# UNITED STATES PATENT AND TRADEMARK OFFICE

| APPLICATION NO. | FILING DATE | FIRST NAMED INVENTOR | ATTORNEY DOCKET NO. | CONFIRMATION NO. |
|-----------------|-------------|----------------------|---------------------|------------------|
| 10/534,092      | 01/13/2006  | Michel Garnier       | 0517-1053           | 2418             |

# Office Action Summary

# ATTACHMENT

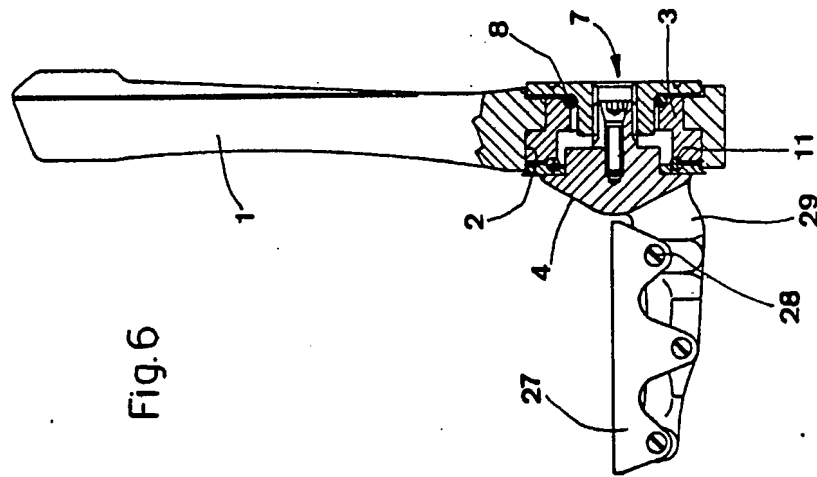
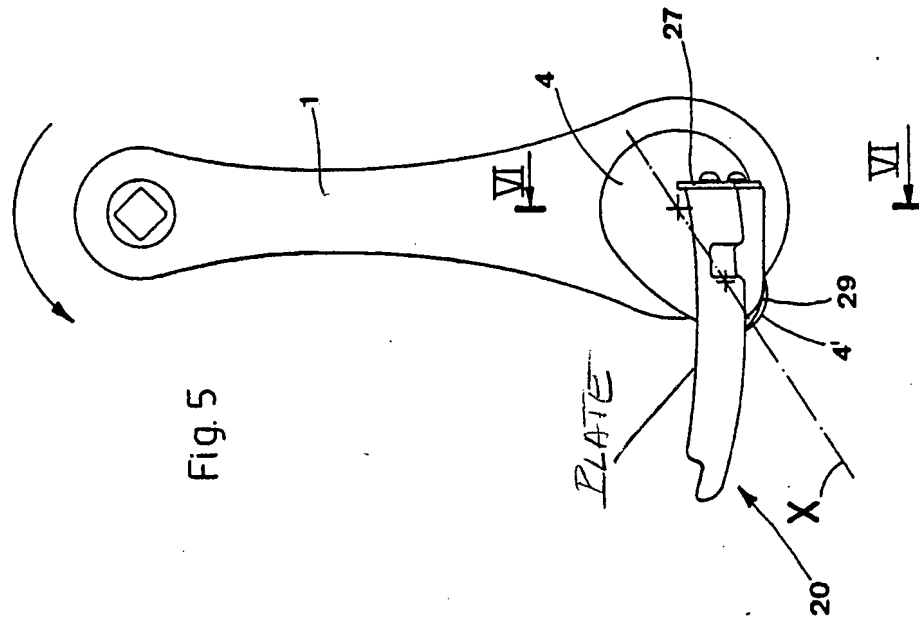
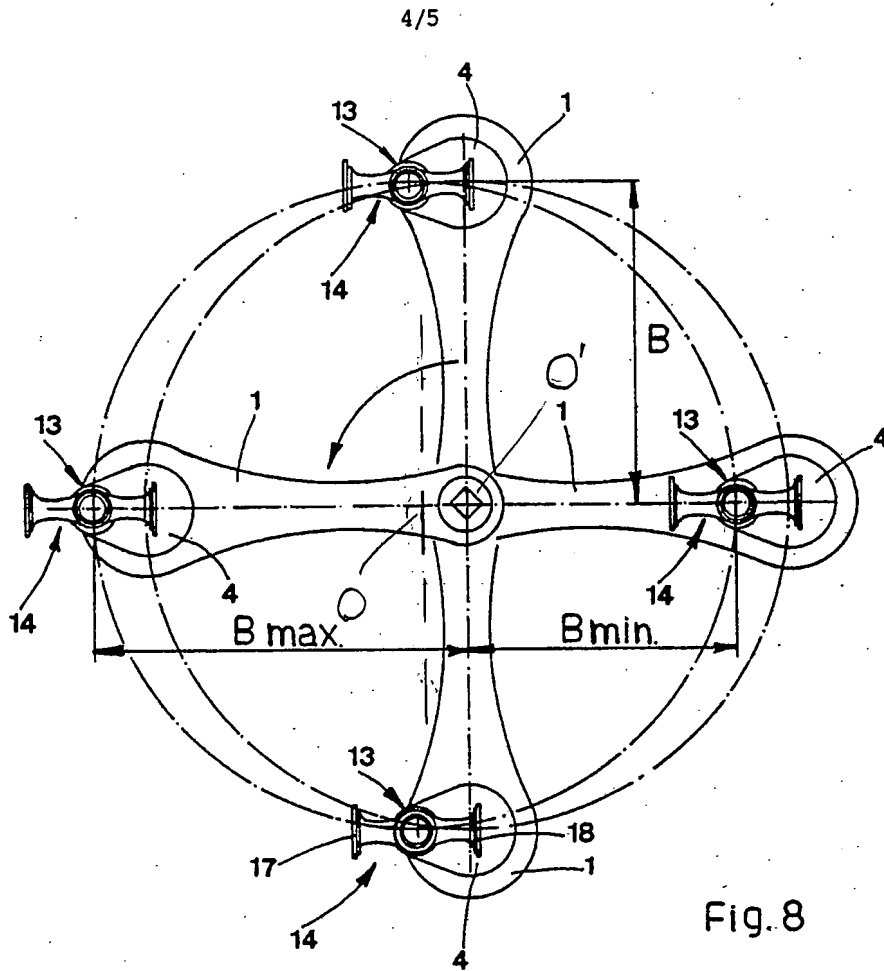
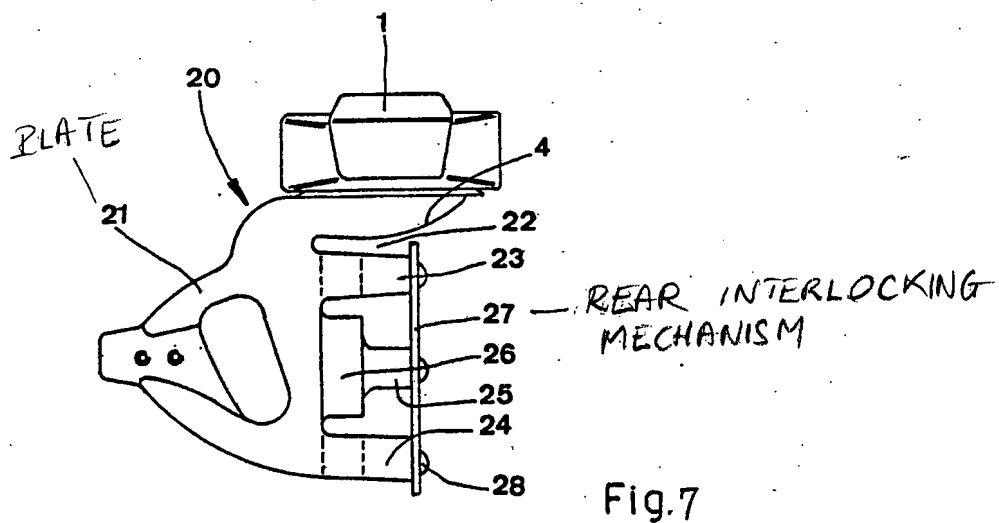
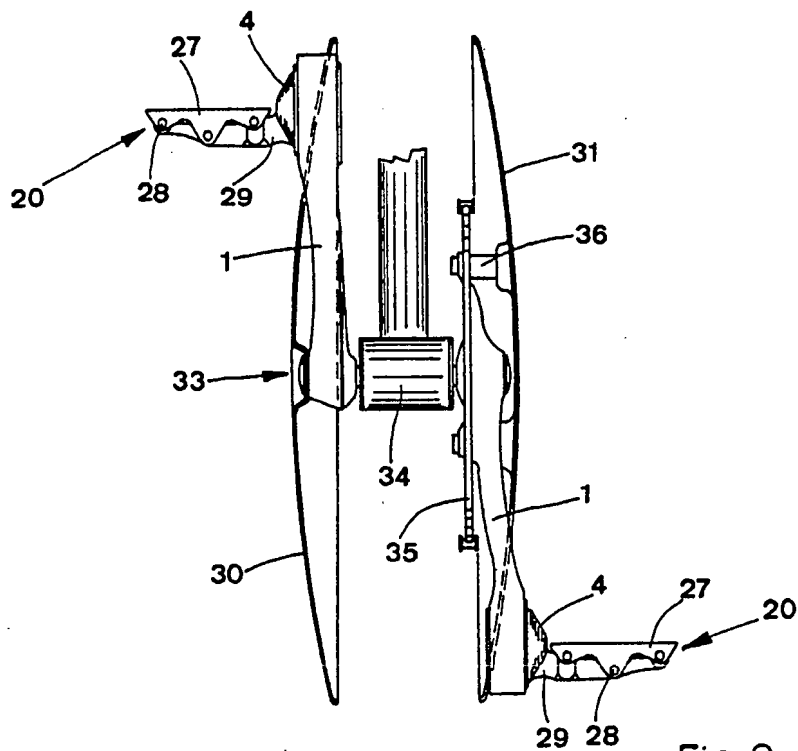
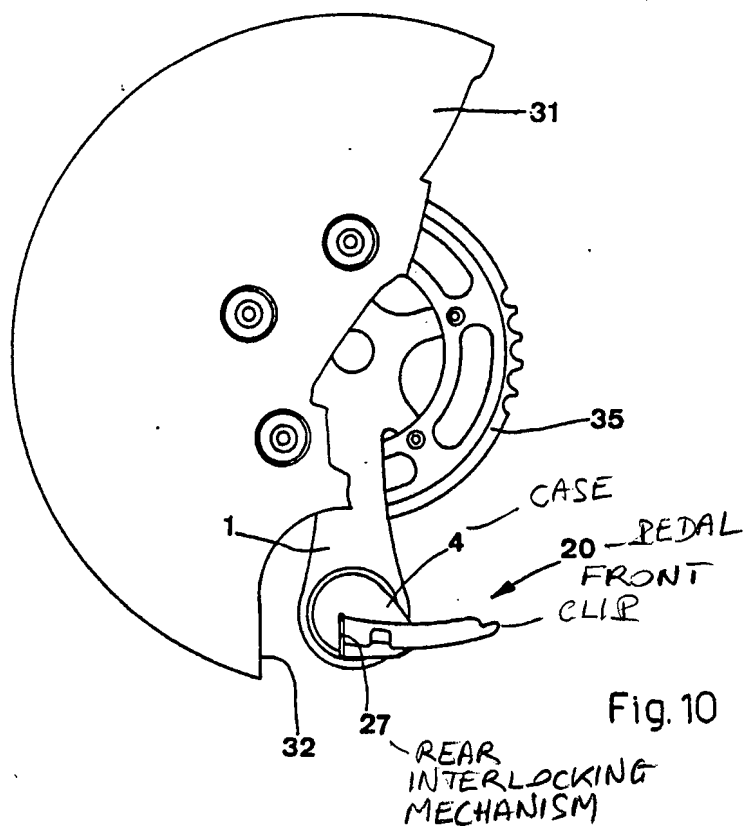
Giorgio teaches a cycle pedal comprising a pedal body 14 or 20 constituted of a *globally* rectangular horizontal plate 17, 18 or 21 (see Attachment hereinafter “Att.”) fitted on its upper surface with means 19 or 27 for locking a cyclist's shoe and on one of its longitudinal edges, a case 4 containing a pedal pin 7 designed to be fixed to the free end of a crank 1 characterized in that the plate 17, 18 or 21 is secured to the case 4 so that its upper surface extends beneath the pedal pin 7 along a distance E (FIGS. 1 and 2) and the support axis of the shoe (not shown) on the

pedal plate 17, 18 or 21 which merges with the front plate capable of passing through the metatarsus of the cyclist's big toe when the latter is pedaling, extends in front of the pedal pin 7 along a distance C, D (FIG. 3) so that the pedal support axis 7 describes a circular curve with centre (unnumbered in FIG. 8) and radius (FIG. 8) offset from downward and from forward relative to the circular curve (FIG. 8) of the pedal pin 7 with centre O (FIG. 8 of Att.), where O' (FIG. 8 of Att.) is the axis of the cycle bottom bracket shell and of radius r and in that the means for locking 19 or 27 comprise, on one hand, a front interlocking mechanism 18 (FIG. 3) or unnumbered in FIG. 10 (Att.) designed to co-operate with the front part of a clip integral with the sole of the cyclist's shoe and, on the other hand, a *movable* rear interlocking mechanism 17 (FIG. 3), 27 (FIG. 10) designed to co-operate with the rear part of the clip of the shoe, the *movable* rear interlocking mechanism 17, 27 being *movable* under the pressure of the rear part of the clip of the shoe from a position called interlocked, and passing through an open position allowing to insert or remove the rear part of the clip of the shoe, until returning to the interlocking position under stress from an elastic means.
